RE: Lot 3 Block 12 Volcano Cliffs Unit 5 SAD 227

6508 Jade Dr. NW

Grading and Drainage Plan

Pad Certification Date: 3/27/2022 CO Certification Date: 9/21/2023

DRAINAGE PLAN Rio Grande Lingineering PO BOX 93924 ALBUQUERQUE, NM 87199

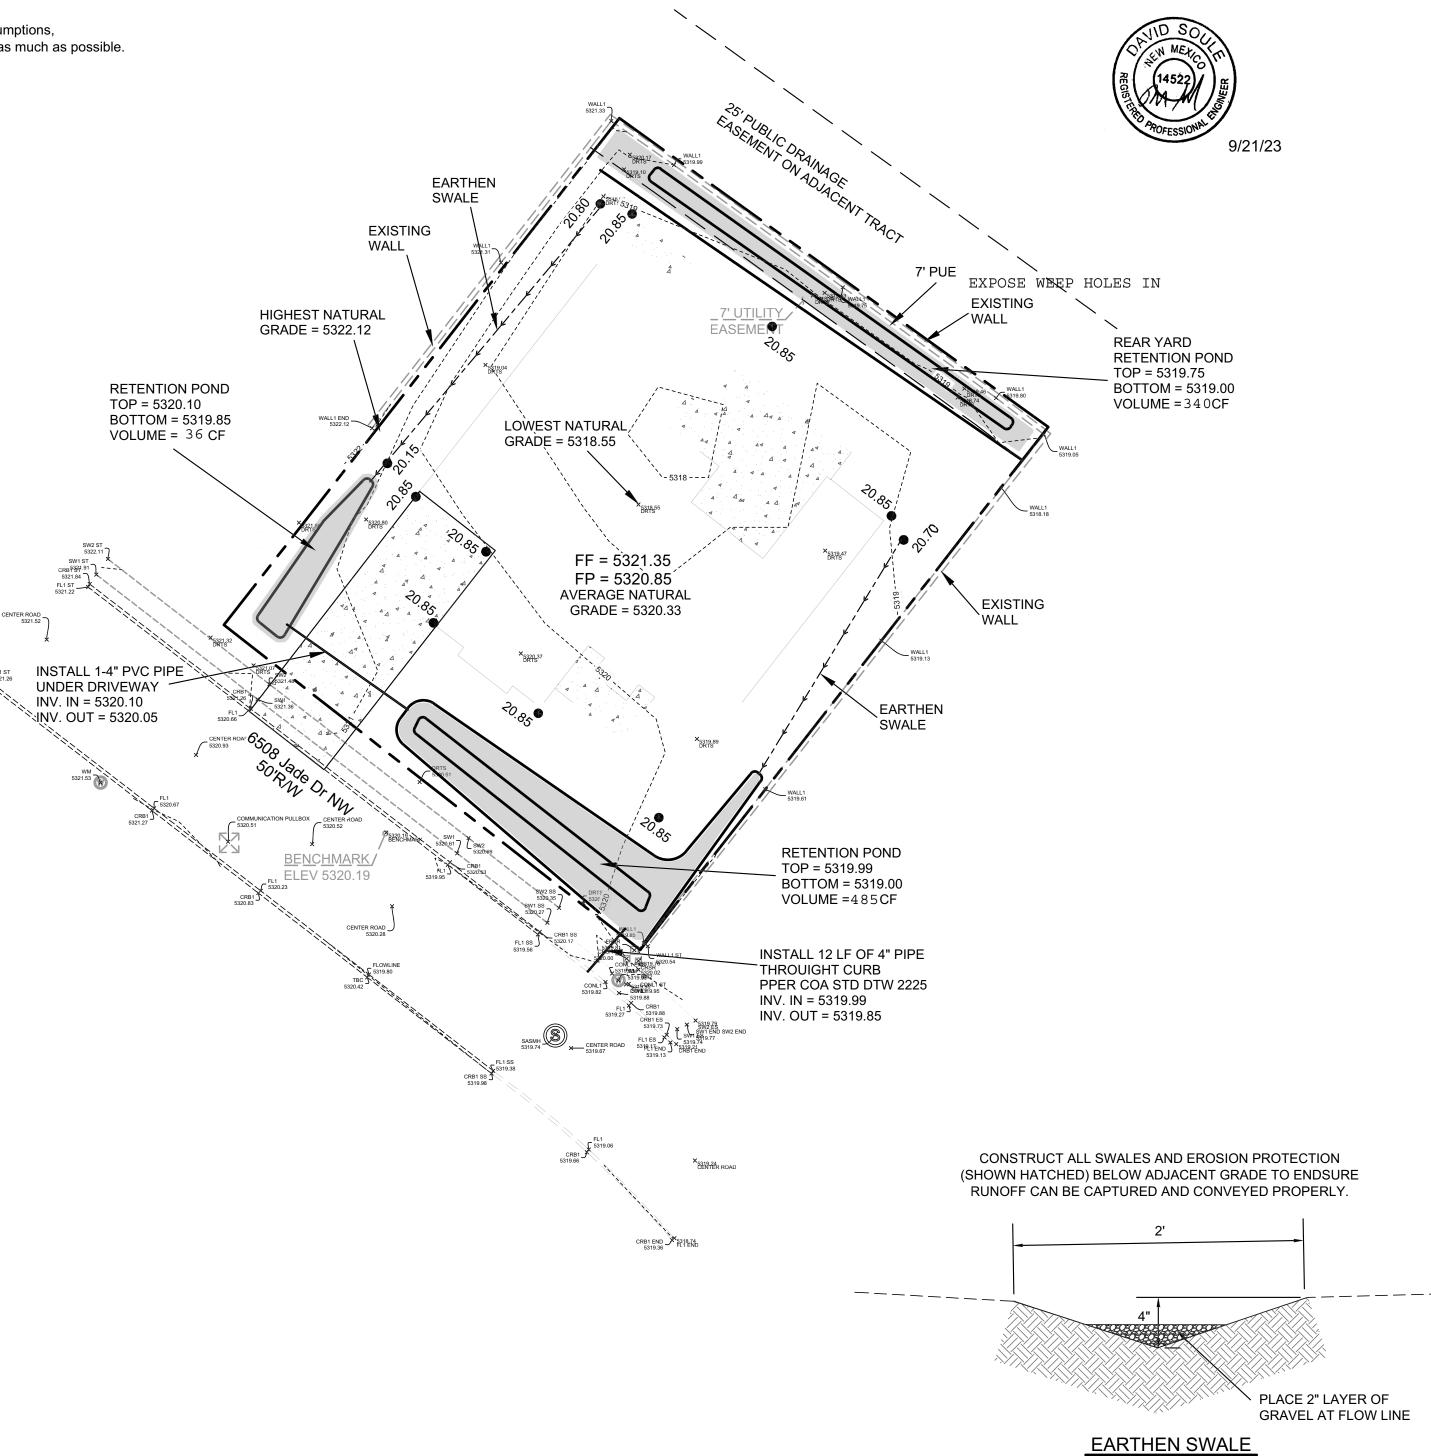
- The port-a-potty needs to be removed.
- The front pond and the exiting piping are at same level. Bottom of pond should be lower than 4-inch piping provided.

• Concrete was placed in areas not accounted for, changing the land treatments for this site. Flows are not working as shown on previous submittal. On the plan provide the foot print of the home built. Show drainage easement on plan.

• Flows on the front east side are flowing into neighbor's property. It appears that flows are leaving this site immediately, with no retention at all. May need to submit a new G&D plan
